Contract #: 04-0120F4Cty: SF/ALA Rte: 80 PM: 13.2/13.9File #: 69.25B**QUALITY ASSURANCE -- NON-CONFORMANCE REPORT****Location:** Changxing Island, Shanghai, PRC**Report No:** NCR-000056**Prime Contractor:** American Bridge/Fluor Enterprises, a JV**Date:** 06-Jan-2008**Submitting Contractor:** Zhenhua Port Machinery Company, Ltd (ZPMC), Changxing Island**NCR #:** ZPMC-0055**Type of problem:**

**Job Name:** SAS Superstructure

**Subject:** NCR No. ZPMC-0055

PROJECT: SAN FRANCISCO OAKLAND BAY BRIDGE

WELD NUMBER: MUC-MA107B/C-2A/2B

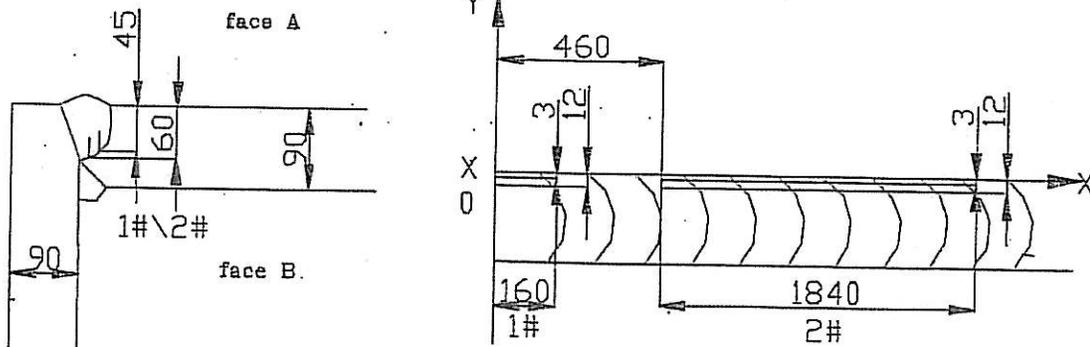
缺陷焊缝长度超过检测长度的10%。(MUC-MA107B/C-2A、2B)

Rejectable indication found by ultrasonic inspection exceeds 10% of the weld size.  
(MUC-MA107B/C-2A、2B)

WHAT IS QC DOING TO "IMPROVE" MONITORING TO ENSURE COMPLIANCE?

1. Preheat before gouging, the temperature is not below 65°C;
2. Gouge off the defect weld completely, and must prepare a right joint, the joint details should refer to the approved WPS-repair;
3. Grind smoothly the gouged surface;
4. Check with MT or other NDT method to make sure the defect remove completely;
5. Preheat and the interpass temperature control according to the WPS-repair;
6. Postheat after welding, keep the temperature between 230° and 315°C. Deciding how long the postheat time is according to the gouged depth. Usually per 25mm an hour, not less than an hour;
7. Perform NDE in accordance with according to the approved shop drawing.

- 1、碳刨之前必须先进行预热，温度不低于 65° C；
- 2、缺陷被完全清除后，必须准备一个正确的接头型式，具体接头型式请参见对应的修补焊接工艺规程 (WPS)；
- 3、将碳刨处打磨光滑；
- 4、用 MT 或其它的无损检测方法证实缺陷被完全清除；
- 5、修补区域的预热温度和道间温度请见批准后的相应的 WPS；
- 6、焊后进行后热，温度为 230° C~315° C，时间根据返修的深度确定，每 25mm/小时，但不少于 1 小时；
- 7、按图纸要求用探伤检测焊缝。

WELD NUMBER: MUC-MA107B/C-2A/2B

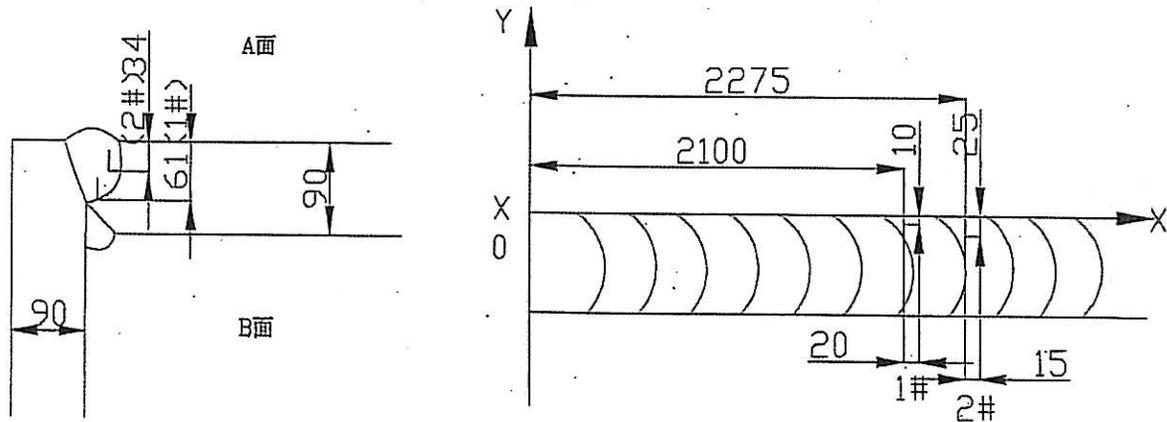
Rejected indication found by ultrasonic inspection is less than the maximum allowance aggregate length. (UT探伤发现的缺陷总长度小于最大允许总长度。)MUC-MA107B/C-2A/2B

1. Gouge off the defect weld;
2. Grind smoothly the gouged surface;
3. If User's request ,check with MT or other NDT method to make sure the defect remove compelety;
4. Preheat and the interpass temperature control according to the relative WPS-repair;
5. Check the welding according to the approved shop drawing.

- 1、 请将有缺陷的焊缝碳刨去除；
- 2、 将碳刨处打磨光滑；
- 3、 如用户要求，用 MT 或其它的无损检测方法证实缺陷被完全清除；
- 4、 按批准后返修焊接工艺规程 WPS 要求进行预热和控制道间温度；
- 5、 按图纸要求检测焊缝。
